00 Ground Floor Proposed

opening infilled North East Stables Elevation Proposed

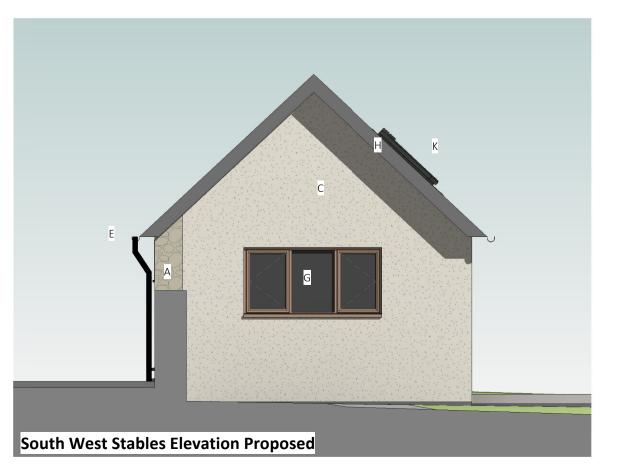
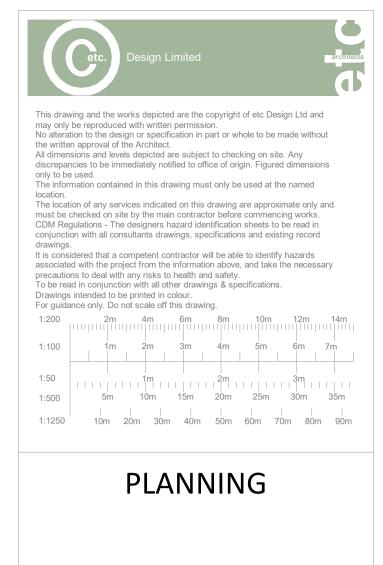
P02 HF 10/23 Updated following planning comments
